April 3, 2024

IDEA Public Schools Upper RGV Mechanical Upgrades CSP#23-URMU-0424

ADDENDUM NO. 2

DATE: MARCH 15, 2024
CHECKED BY: B.B.
DRAWN BY: D.G.
PROJECT NO.: 23V78
CAD FILE:
SHEET: **ME5.4**

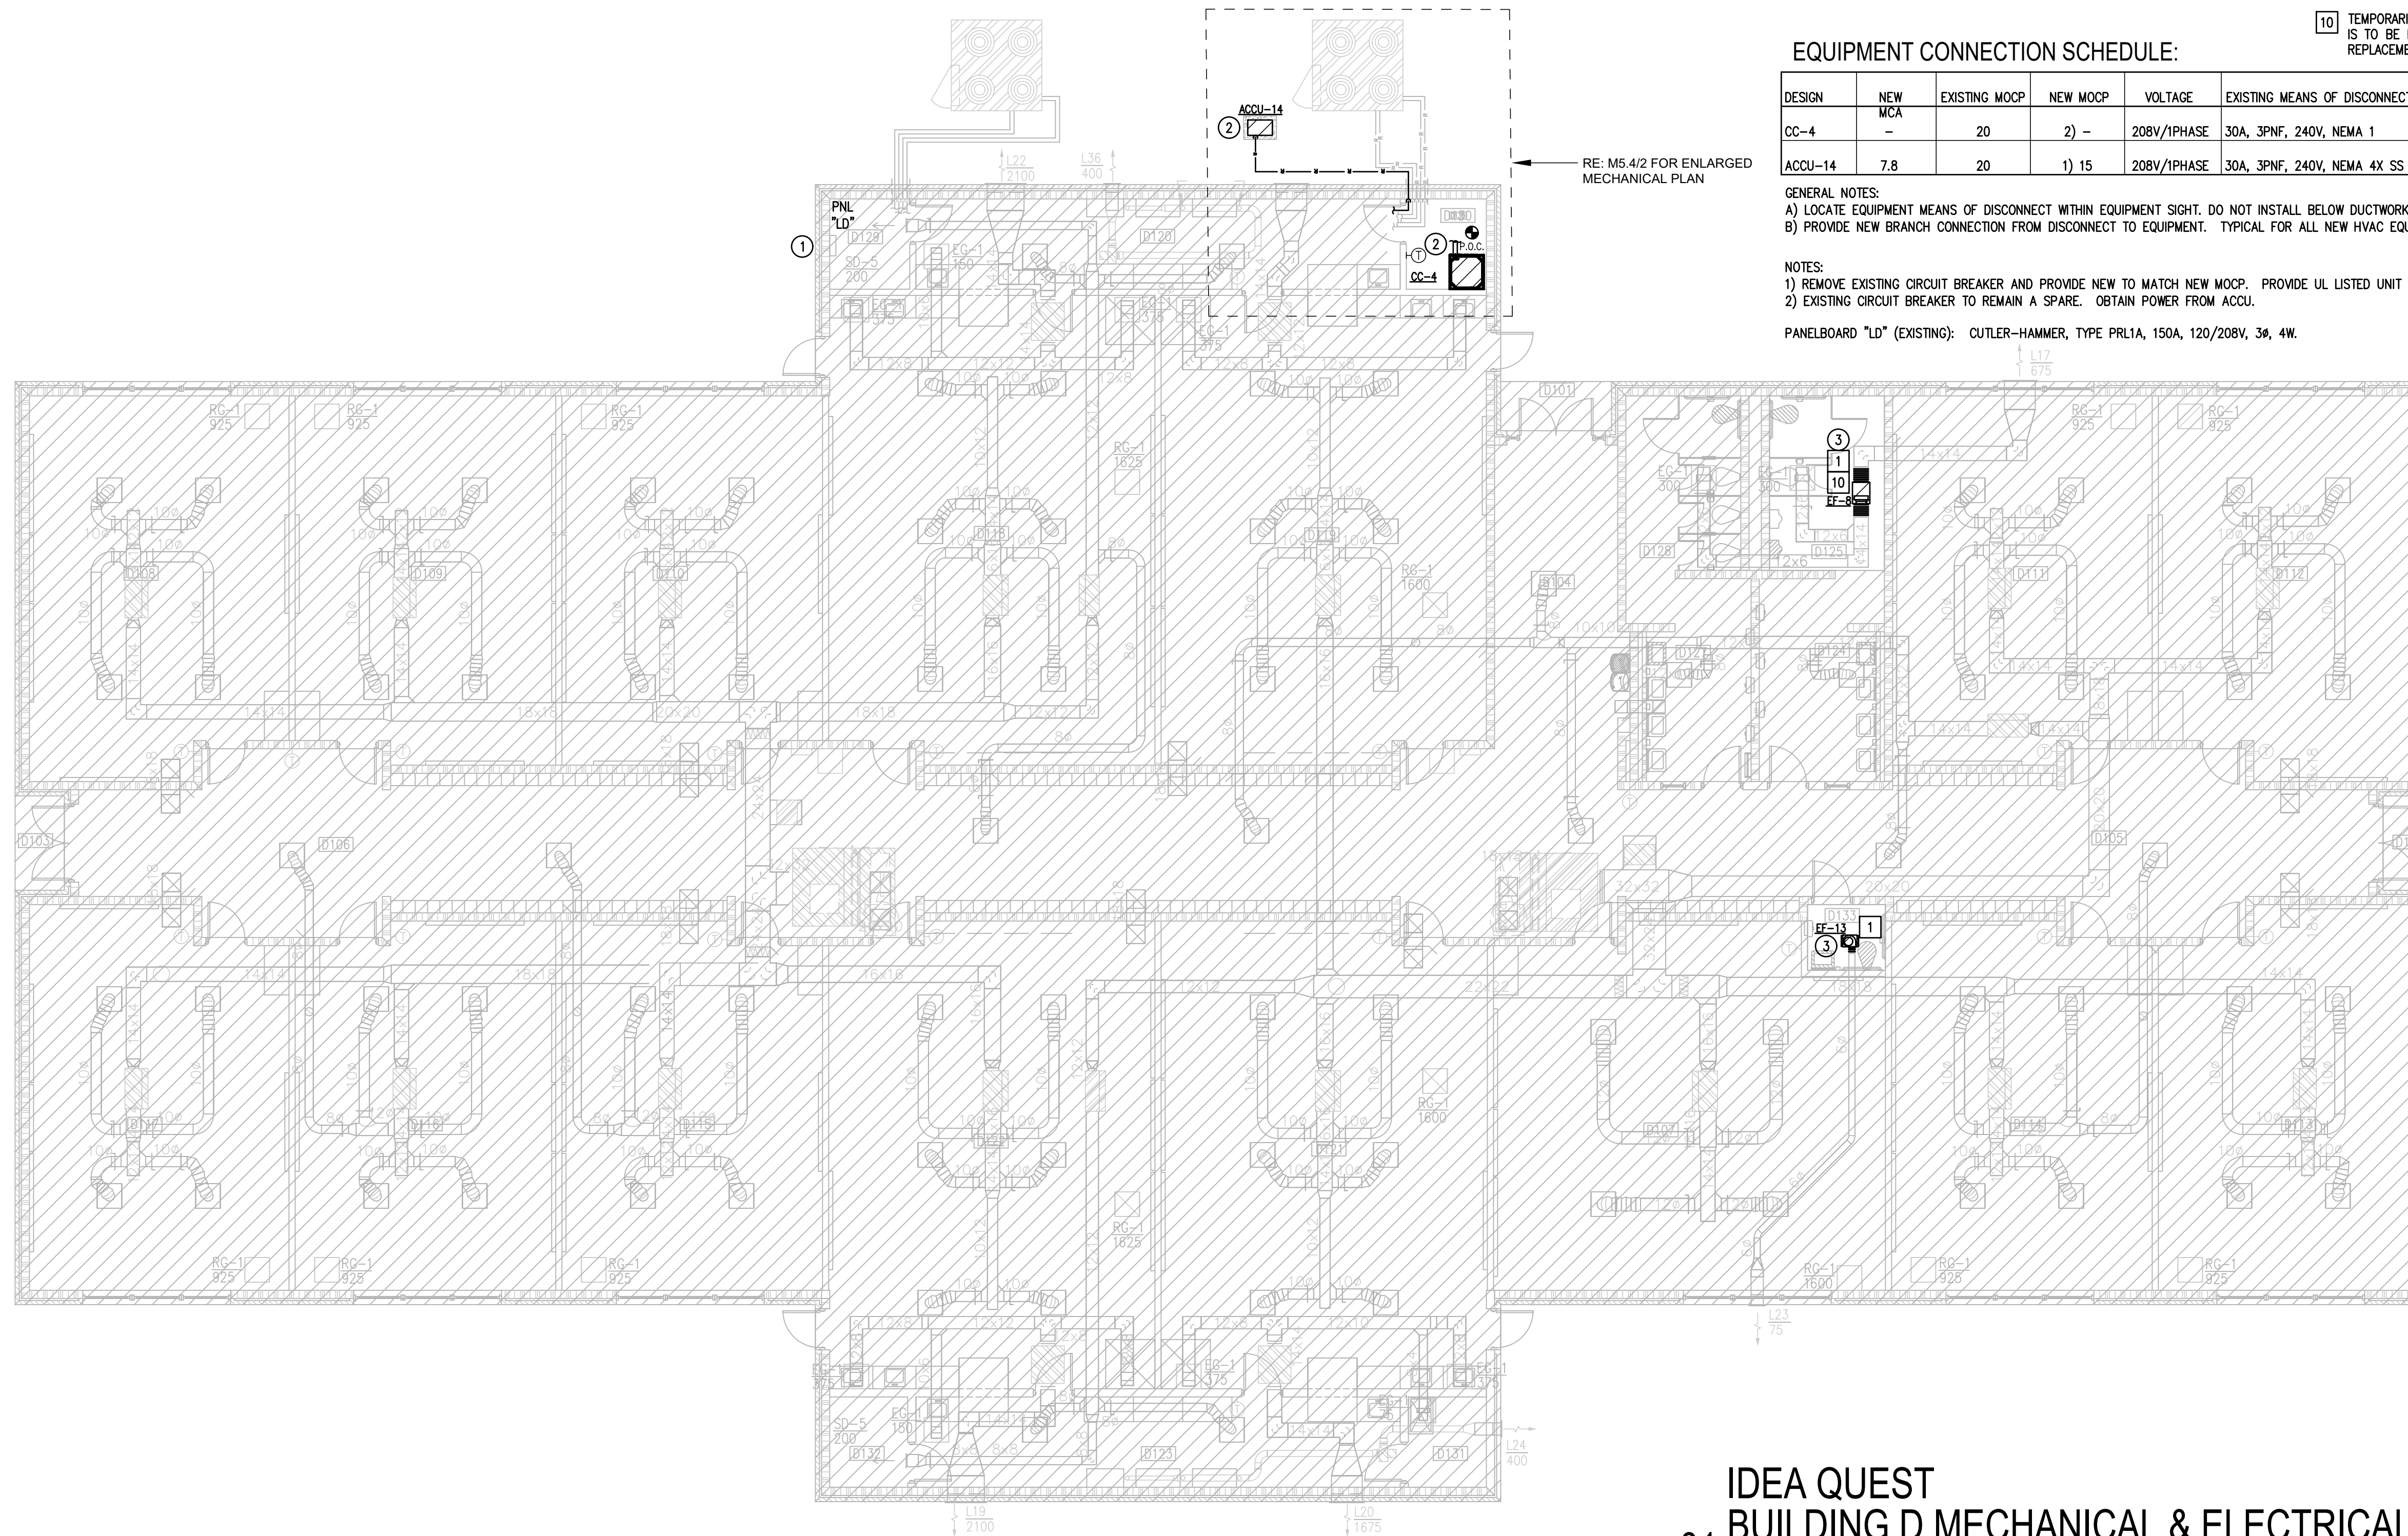
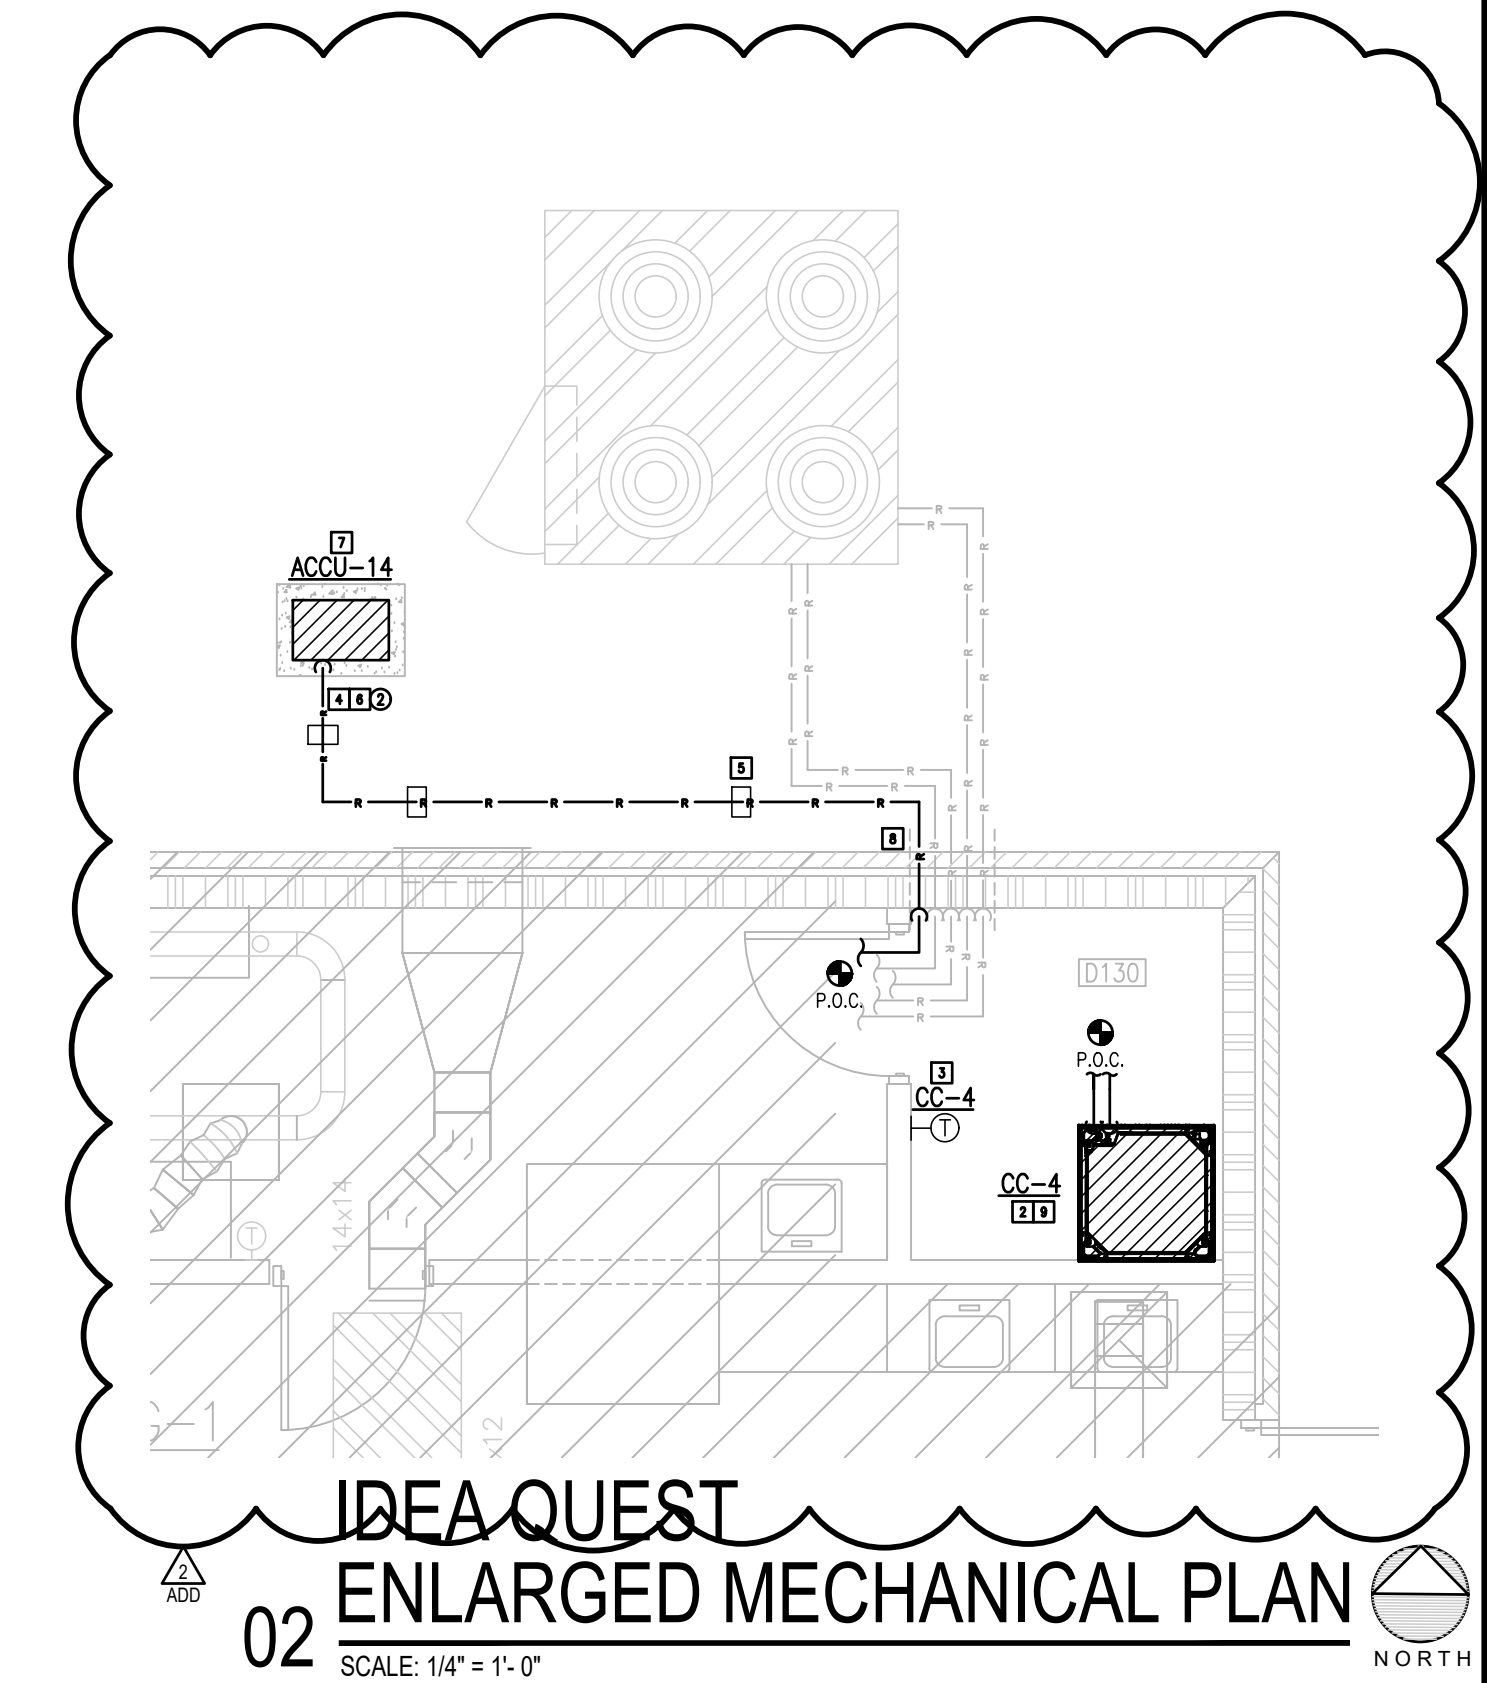
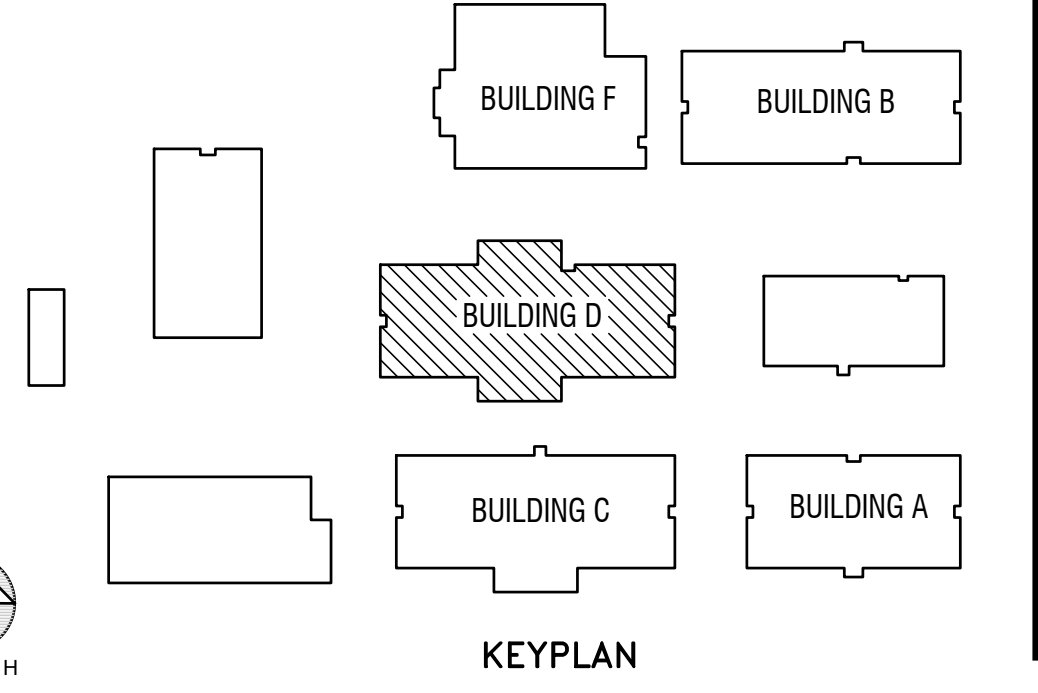
- a) Added Base Bid identification to schedules.
12. Sheet ME-5.4 – See attached.
 - a) Added Base Bid identification to schedules.
 - b) Updated mini-split ACCU location.
